NEW CONTAINEBOARD

PROCESS PIPING AND INSTRUMENTATION DIAGRAM NO. 3 EVAPORATOR REPLACEMENT SURFACE CONDENSER

CTE-51MF-25

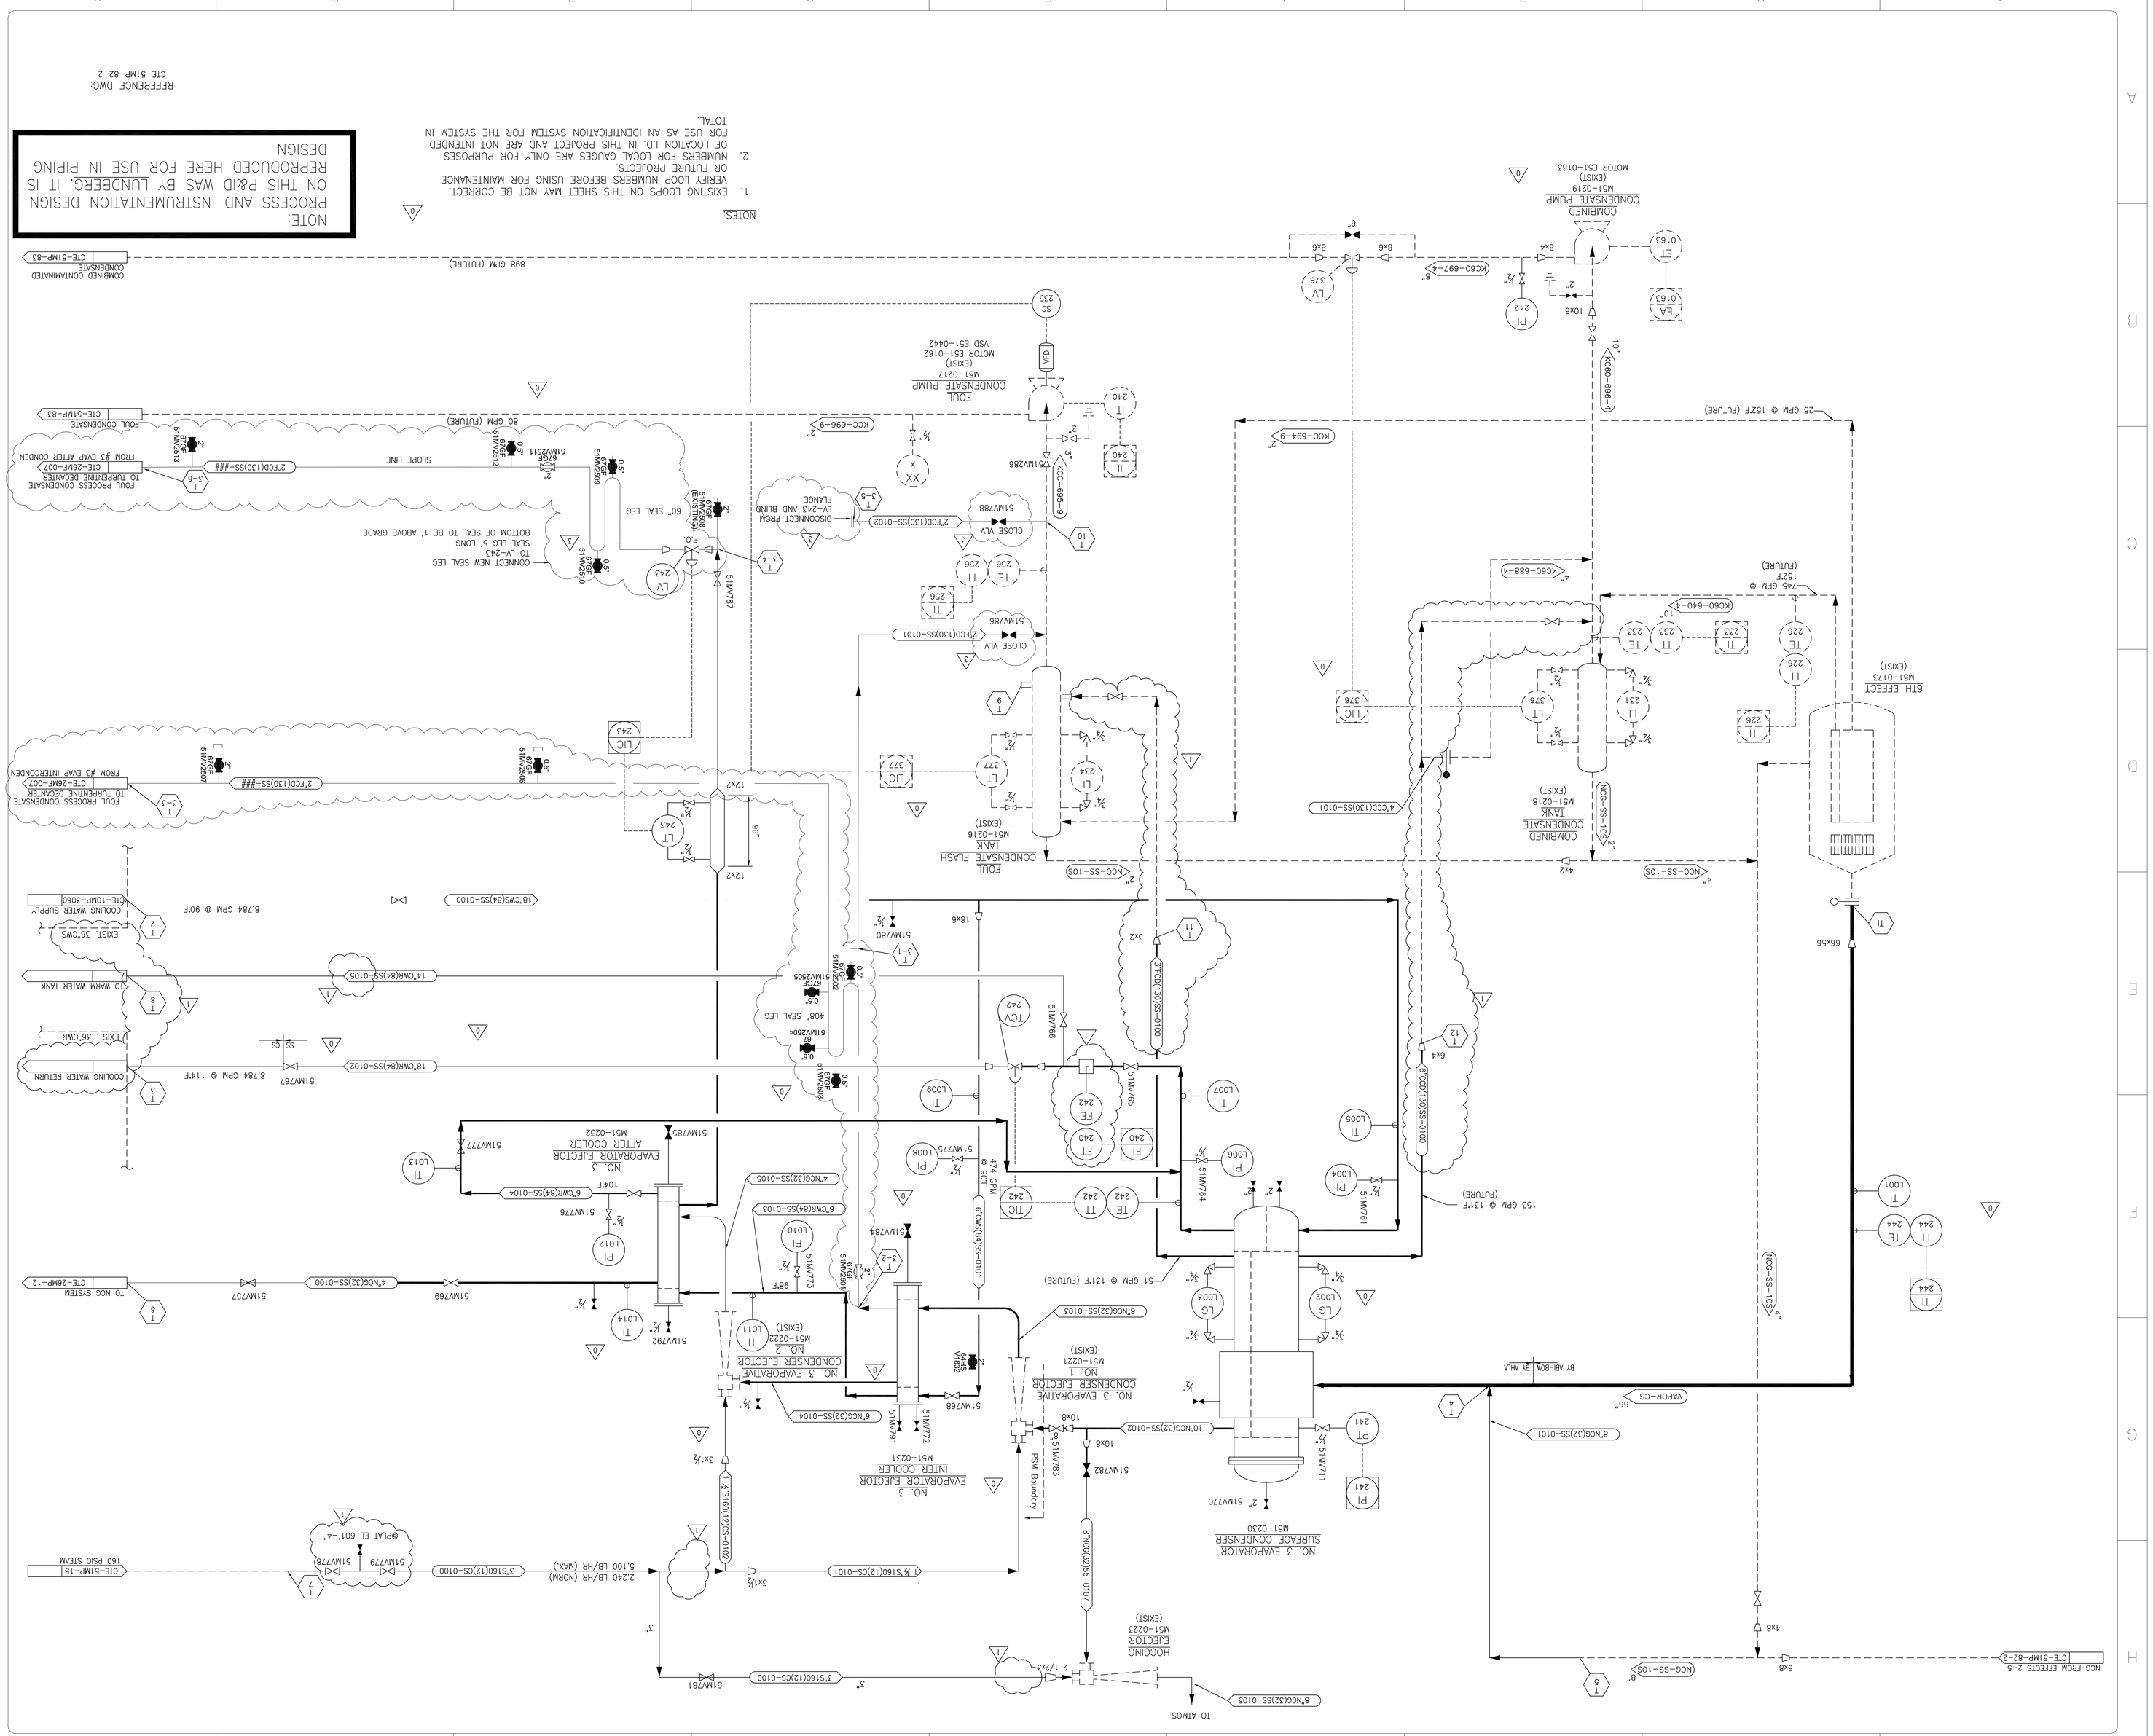
1. Original CTE-51MF-25 was found out of date w/reference to CTE-51MF-25 oil.pdf found in Scandows Draw. MARKED up accordingly

2. 10/21/21-Project enacted to redirect Turpentine laden foul condensate from evaporator LVHC condensates to Turp Decanter under Project CTW-014095.

3. Native file for Rev 2 not located. Manual Valve numbers replicated from PDF File as part of Rev 3

4. Pipe and Valve Specs utilized from Project Columbia for Foul Process Cond.
